ADDENDUM NO. 1

MARKET STREET IMPROVEMENTS and FIFTH STREET ACTIVE TRANSPORTATION STP-5507(607) & TAP-5445(613)

COUNTY OF JEFFERSON, MISSOURI

April 3, 2026

XS SHEET
 SHEET 19 OF 20
 KIMMSWICK GREAT
 STREETS PHASE I

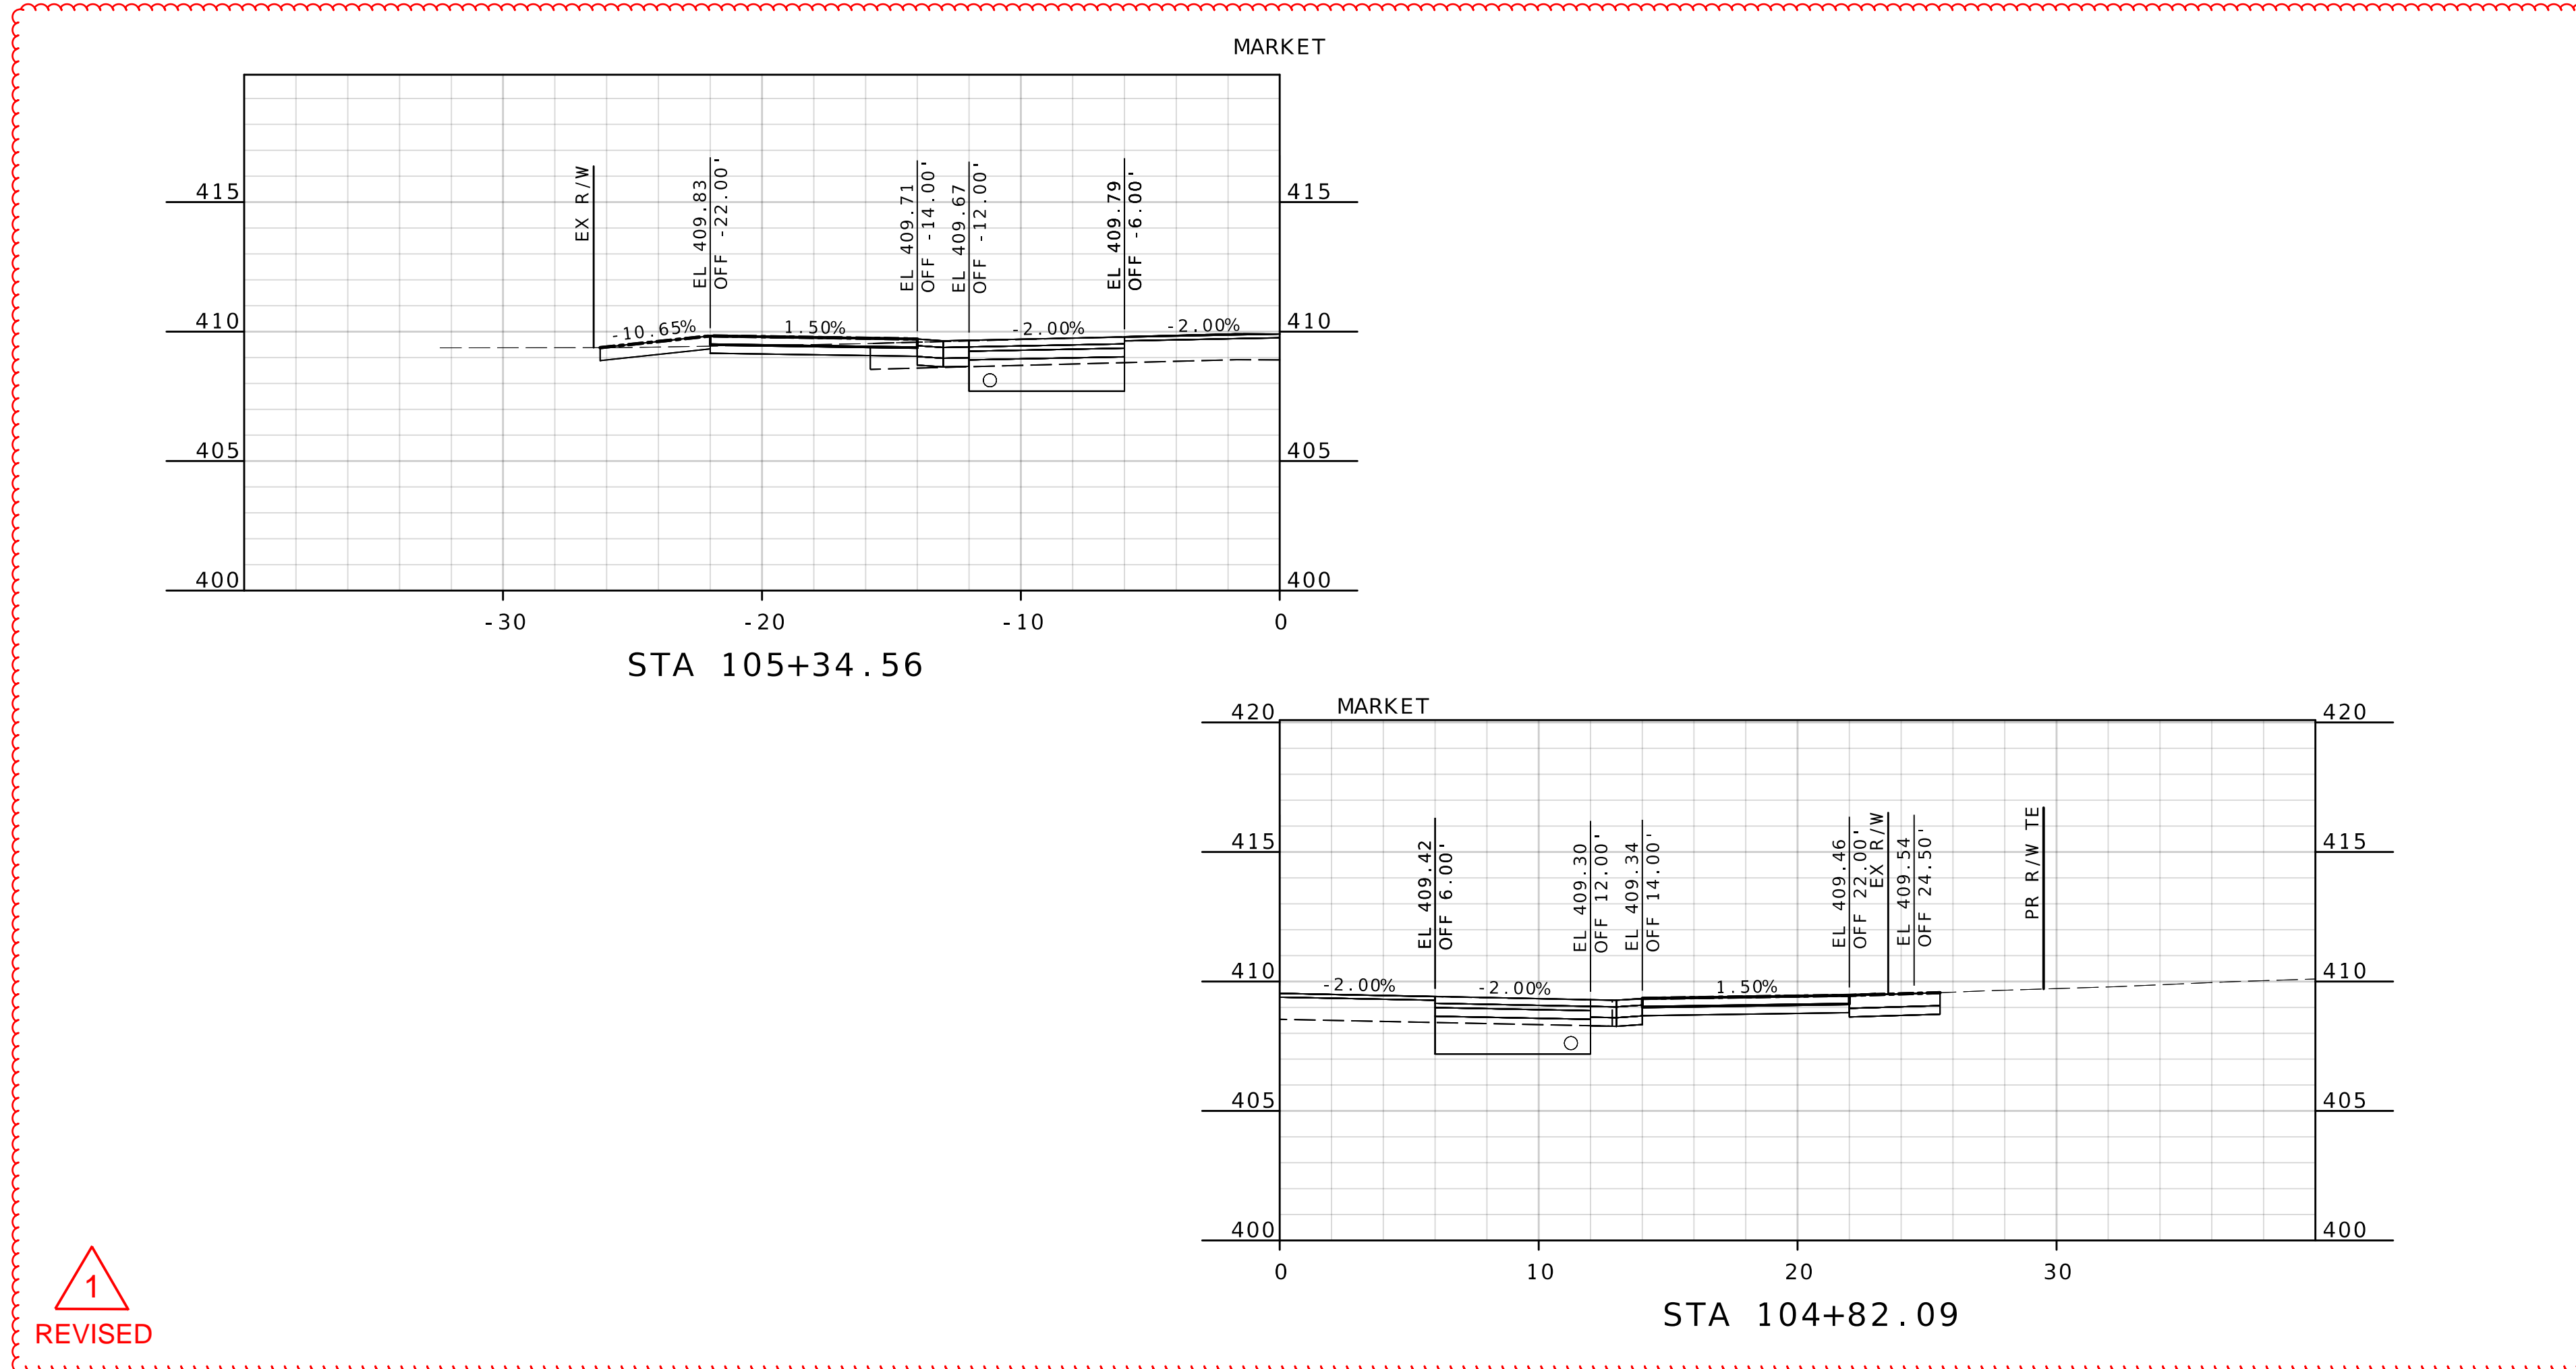
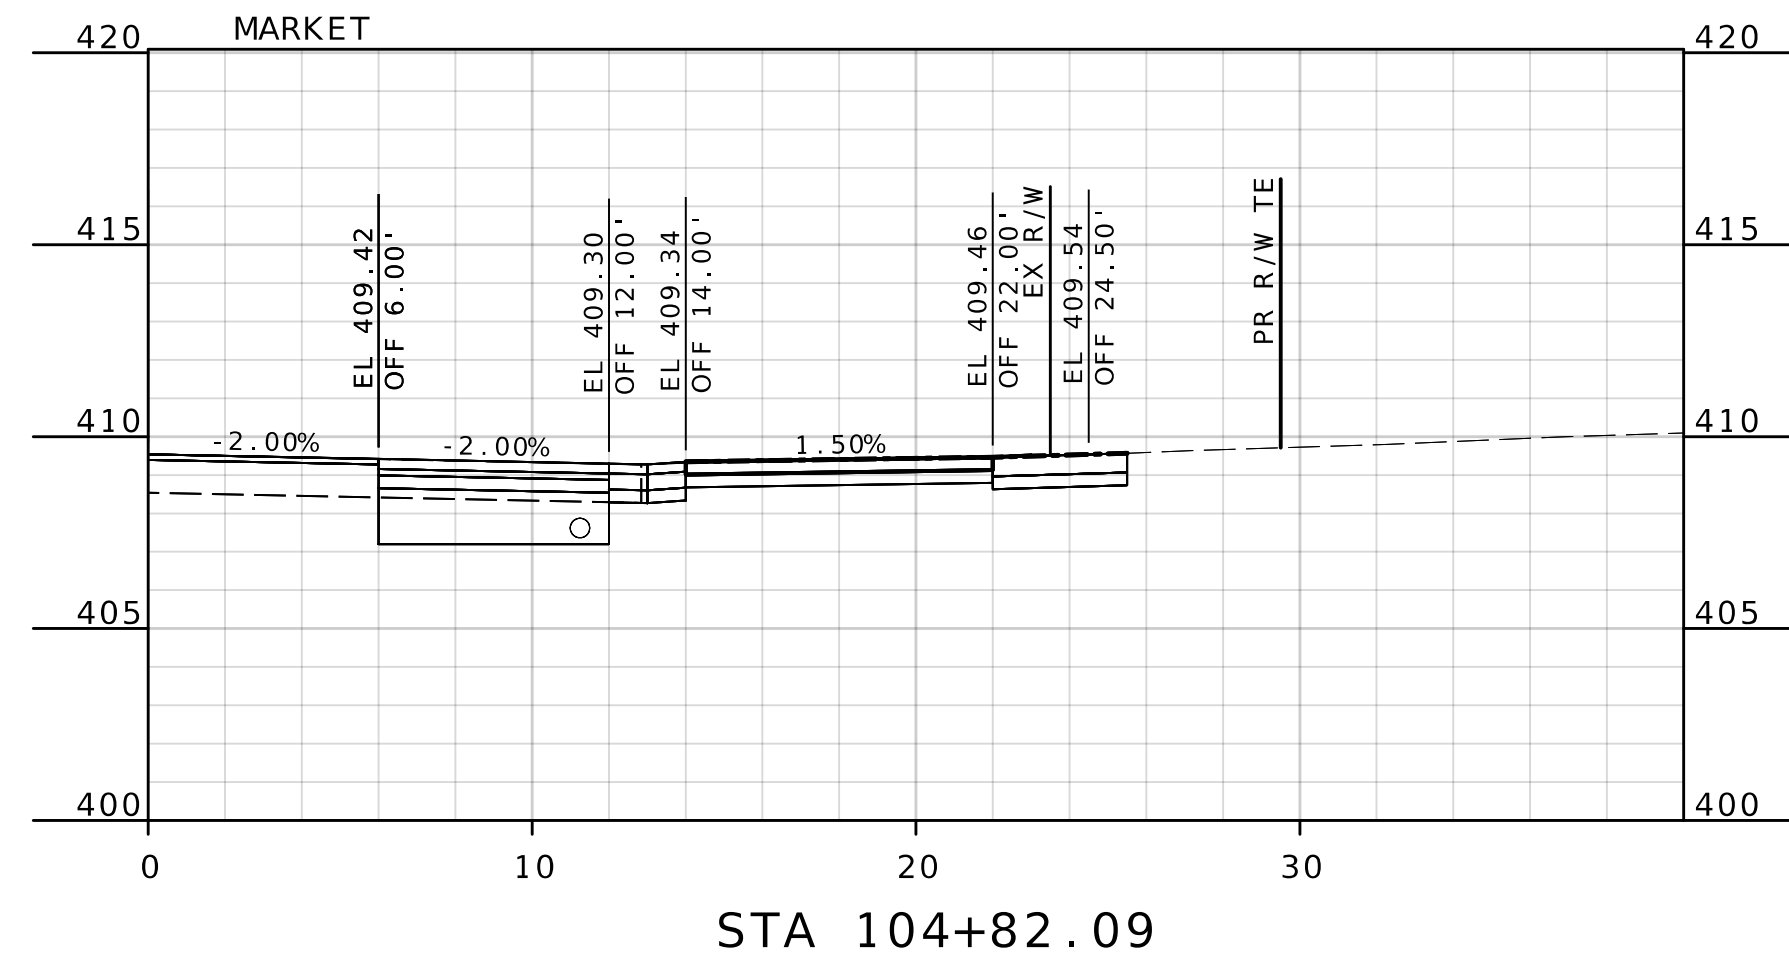
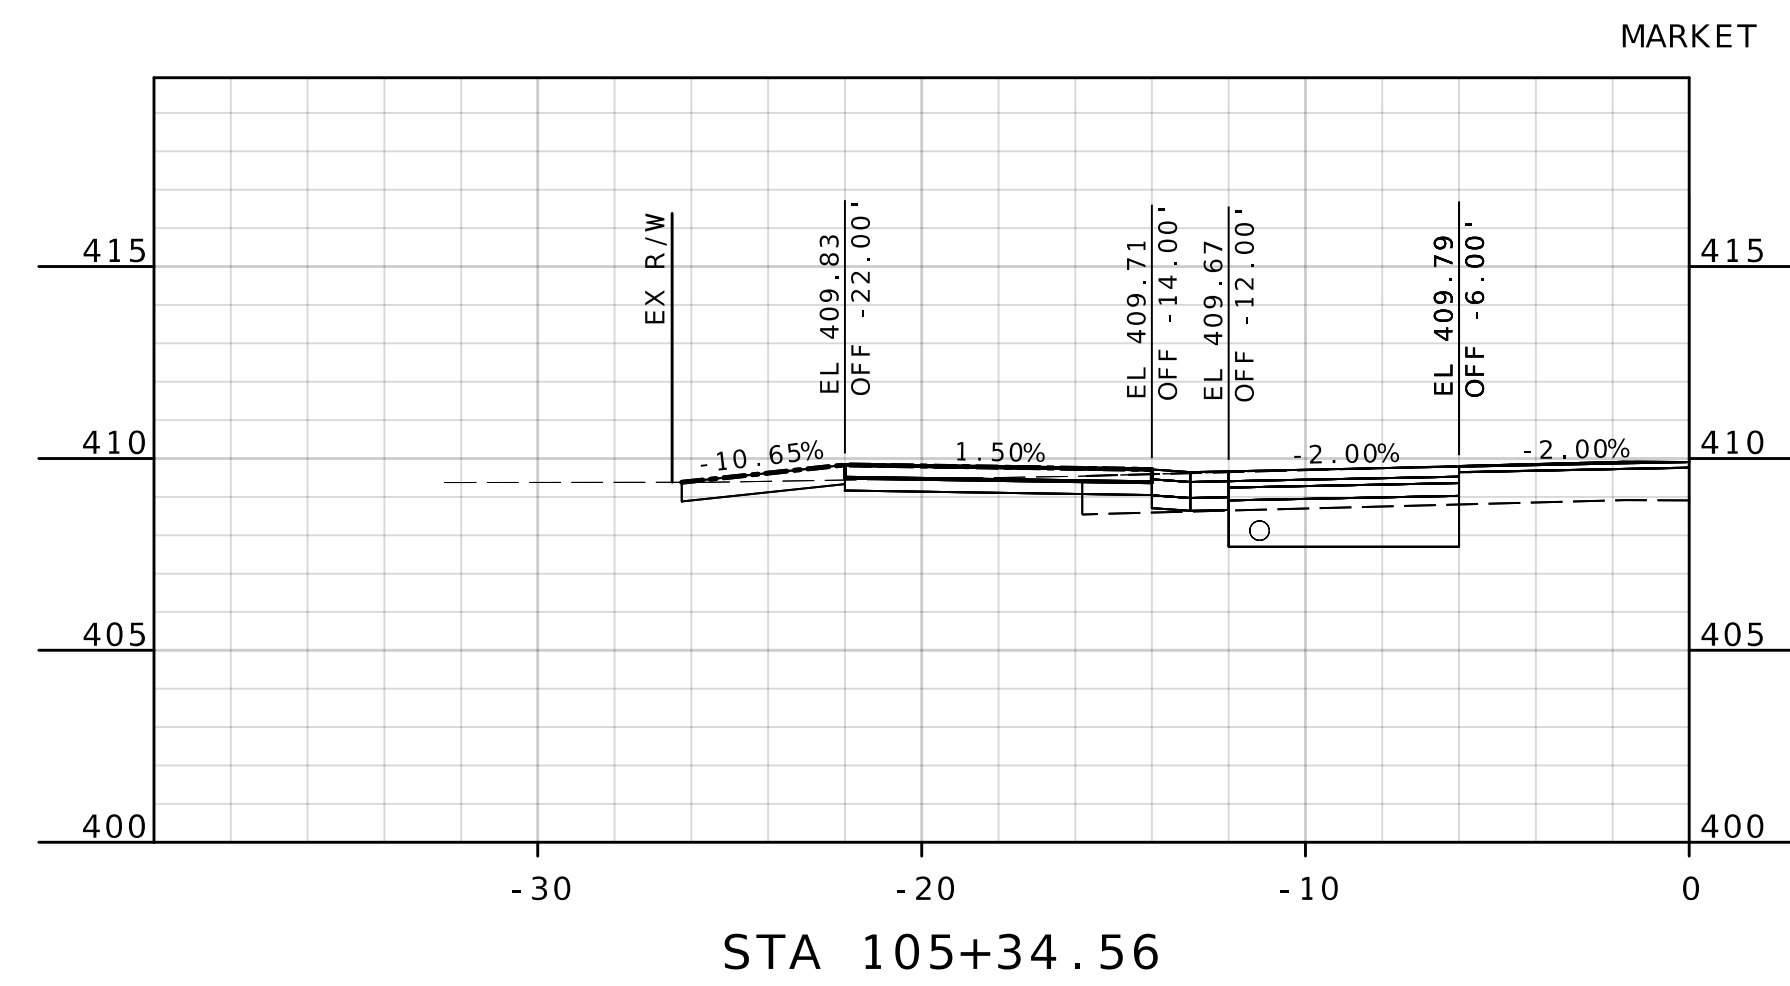
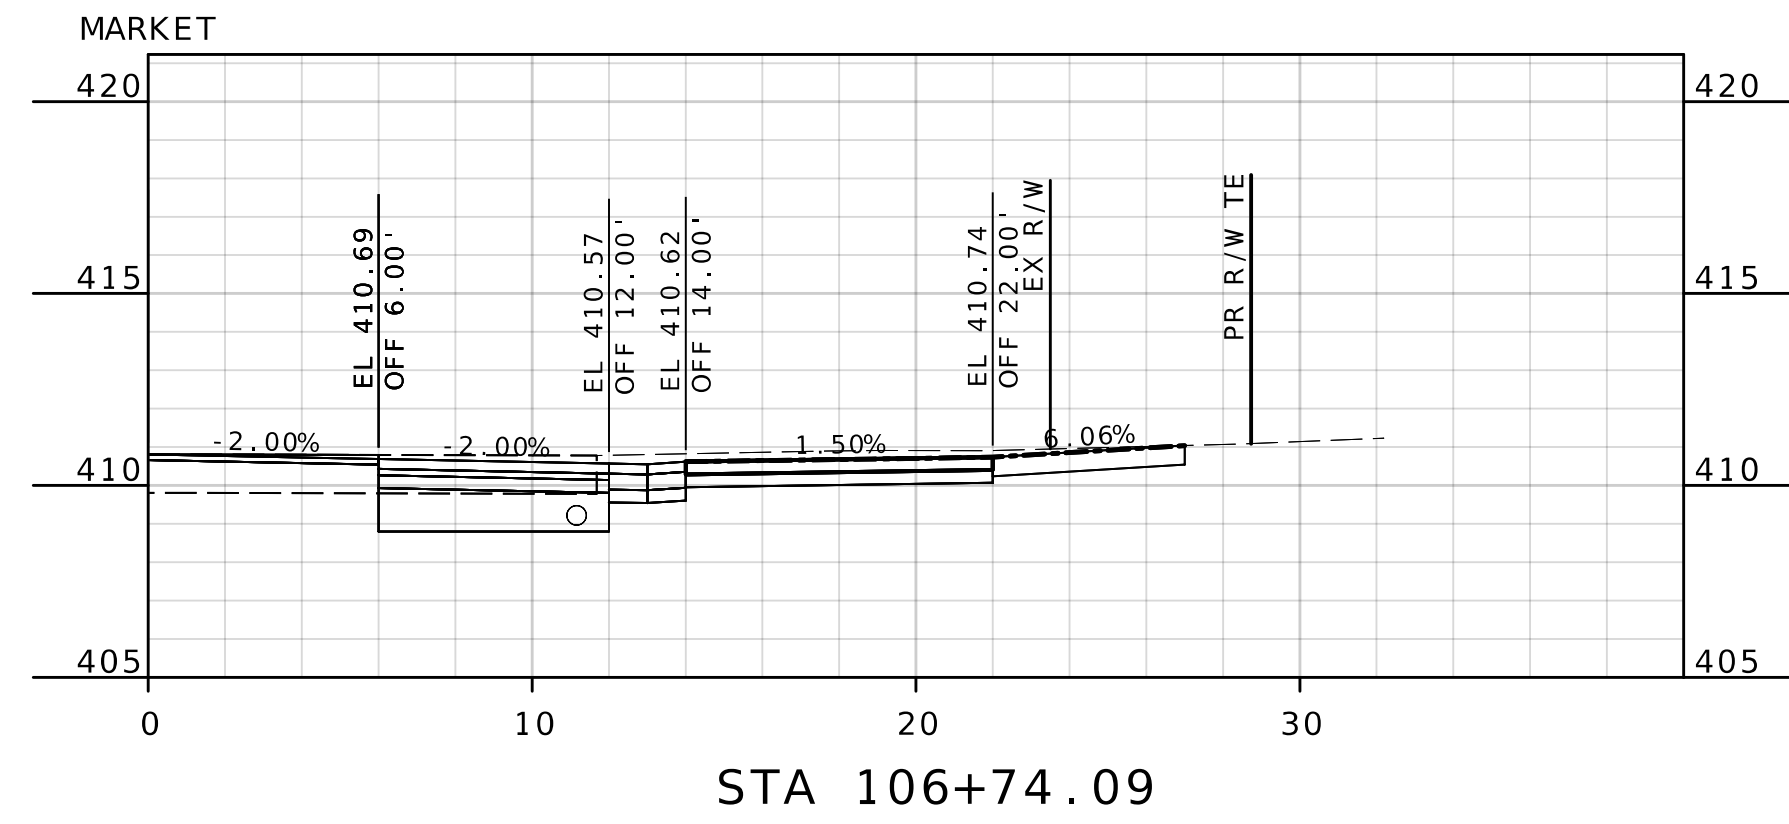
XS Sheet 18 of 20 and XS Sheet 19 of 20 have revisions to the cross sections.
